UNIVERSITY OF FLORIDA
TRAINING REACTOR
LICENSE NO R-56
DOCKET NO. 50-83

SUBMITTAL OF RESPONSES TO NRC
REQUEST FOR ADDITIONAL INFORMATION
FOR THE CONVERSION FROM HIGH-ENRICHED
URANIUM TO LOW-ENRICHED URANIUM FUEL

**University of Florida Training Reactor, Facility License: R-56, Docket No. 50-83
Request for Change in Technical Specifications Approving HEU to LEU Conversion
With Responses to Requests for Additional Information**

Figure Q3-1 Relative Difference between the Peak-to-Average Power Width Profile

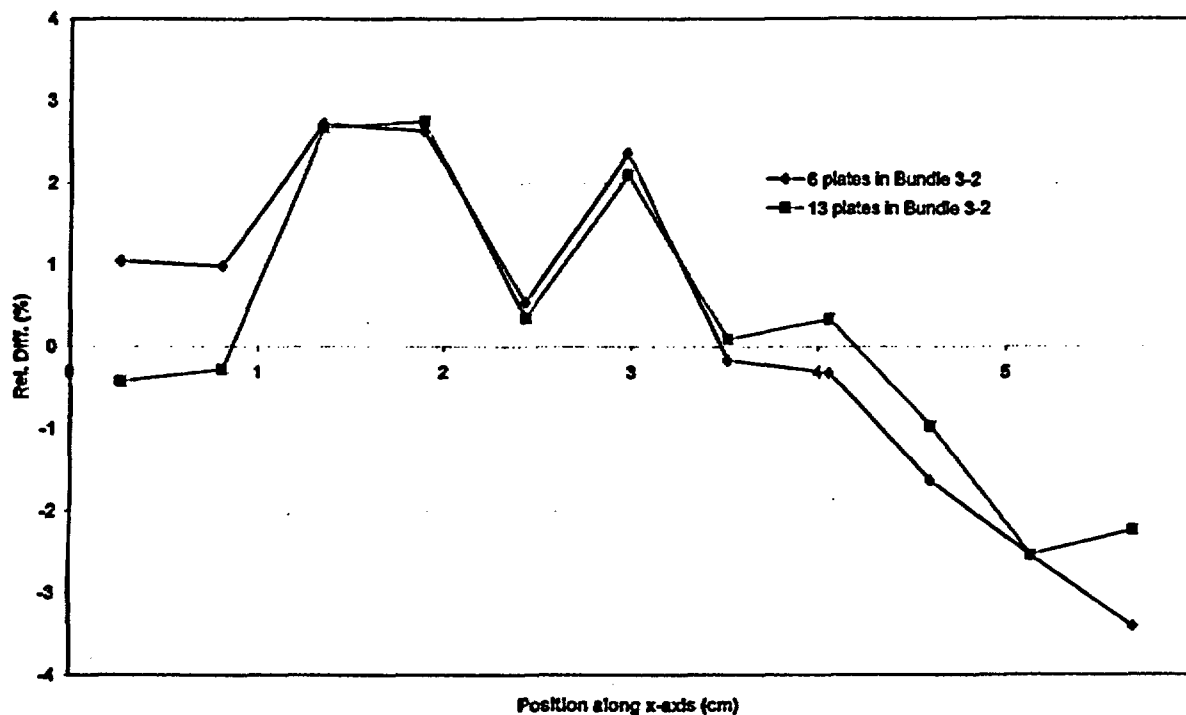
3. Section 4.5, Dynamic Design. Are any changes in fuel element location planned from the LEU reference core during the life of the core and if so, how does that affect the results of the safety analysis?

We expect this need may occur toward the end of life, e.g., 20 years from now; so, it is not an issue for achieving criticality. Due to various uncertainties, the as-built core can differ slightly from the proposed and analyzed core. Therefore, we have analyzed the impact of the number of plates in the partial fuel bundle 3-2 (see conversion SAR Figure 4-15) on the bundle peak-to-average power ratio, the power per plate in the critical bundle, and the width profile in the critical plate. Based on these results (see Appendix Q3 for details), the impact on the thermal-hydraulics analysis for the LEU core is negligible because the changes in the power distributions are very small for a partial bundle with 6 and 13 fuel plates.

The small changes in the power distribution presented in Table Q3-1, Table Q3-2 and Figure Q3-1 will have a minimal impact on the thermal-hydraulics analyses performed in the conversion submittal for the UFTR.

Figure Q6.1 Flow Network for One
LEU Assembly Including Grid Plate

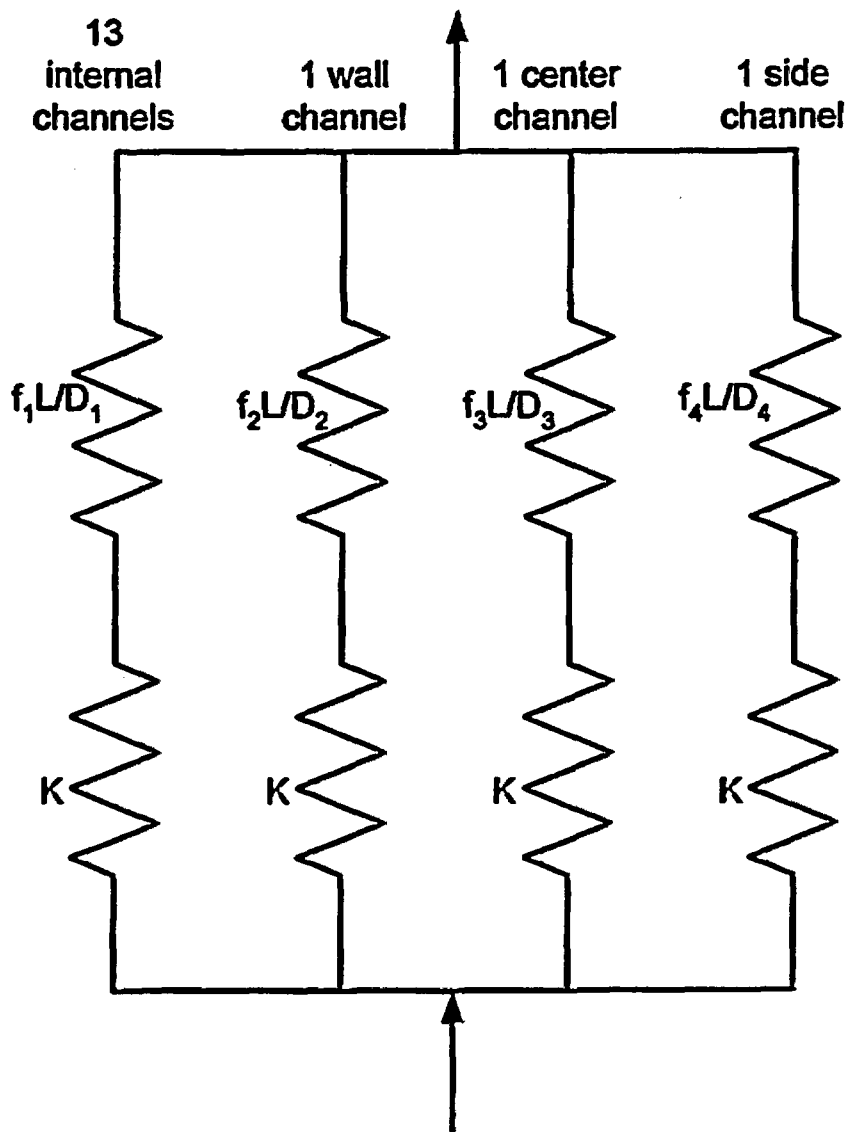
7. 4.7.2 PLTEMP/ANL v2.14 Code Description. The reference (Reference 11) cited for the code PLTEMP/ANL v2.14 is for an earlier version that does not model laminar forced convection. Provide an updated reference that documents the implementation of the new models and the validation of the new models for application to plate type geometries.

As Figure Q6.1 shows, the PLTEMP model for an LEU assembly would have 16 parallel flow paths. For each of these parallel paths or channels the pressure drop, ΔP , is given by:

Figure 4-20 Calculated Values of True Reactor Power at Different True Coolant Flow Rates for ONBR = 1.0 at Three Inlet Temperatures

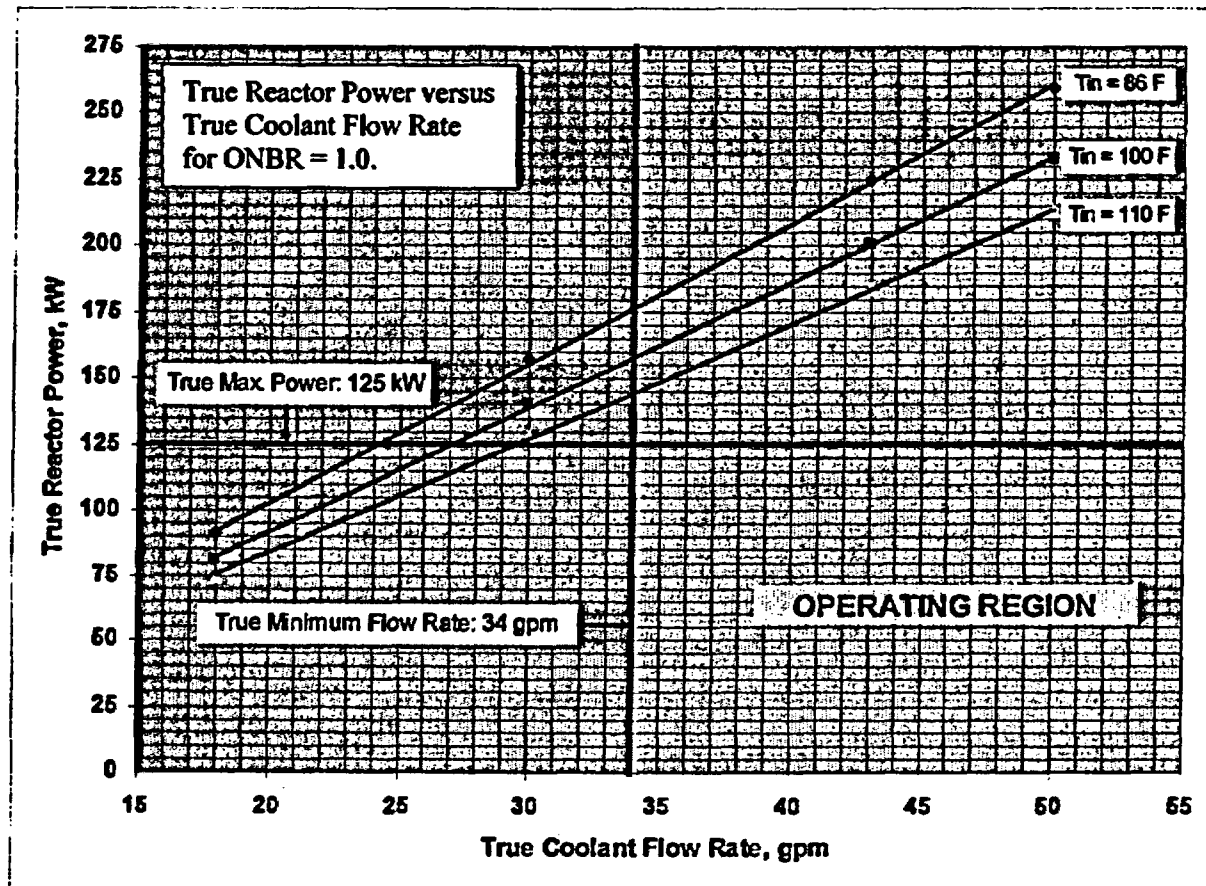
25. TS 2.1. Safety Limits. The regulations in 10 CFR 50.36 define safety limits (SLs) as limits upon important process variables that are found to be necessary to reasonably protect the integrity of certain of the physical barriers that guard against the uncontrolled release of radioactivity. Exceeding a SL means that there is a possibility that the physical barrier has failed. That is the basis for requiring Commission approval for reactor restart if a SL is exceeded. As pointed out in the SAR, fuel cladding is the physical barrier of concern. It is stated that the integrity of the barrier is protected if the cladding temperature is kept below the incipient melting temperature of 582°C for the 6061-aluminum cladding of the LEU silicide fuel (however, NRC has accepted an upper temperature for aluminum-clad fuel of 530°C based on blister formation temperature-see NUREG-1313, "Safety Evaluation Report related to the evaluation of Low-Enriched Uranium Silicide-Aluminum Dispersion Fuel for Use in Non-Power Reactors," Section 3.3.3). You have based your SLs on the prevention of localized boiling. This results in SL process variable values significantly below those needed to protect against clad blister.

As a result, in some cases, the accident analysis does not appear to support the technical basis for the SLs. For example, for the analysis of a step addition of reactivity of 0.6% dk/k into the core, the peak power for the LEU core with a SCRAM occurring is 320 kW. This would violate the SL in the proposed Technical Specification 2.1, namely, that "the power level shall not exceed 190 kW." Also, this result would indicate that the limiting safety system setting (LSSS) of 125 kW would not be in compliance with the regulations in 10 CFR 50.36(c)(1)(ii)(A) which states when a LSSS is specified for a variable on which a SL has been placed, the setting must be so chosen that automatic protective action will correct the abnormal situation before a SL is exceeded.

Please propose revised SLs and LSSSs, as needed, that support the conclusions in your accident analyses for reactivity insertions and loss-of-coolant or explain why the proposed values in your SAR are acceptable.

The value of 582°C will be changed to 530°C. This has no impact on the conclusions. The following figure provides information for selection of Limiting Safety System Settings (LSSS). Plotted in the figure are true reactor power versus true coolant flow rate for ONBR = 1.0 for three values of the coolant inlet temperature.

Based on the above figure, UFTR has decided on LSSS as follows: Power is 119 kW, coolant flow rate is 36 gpm, inlet temperature is 109 F, and outlet temperature is 155 F. These parameters were selected to account for uncertainties in measurements of the reactor power ($\pm 5\%$), coolant flow rate ($\pm 5\%$), and coolant inlet/outlet temperature ($\pm 1^\circ\text{F}$). Detailed analyses are provided in Appendix Q8.
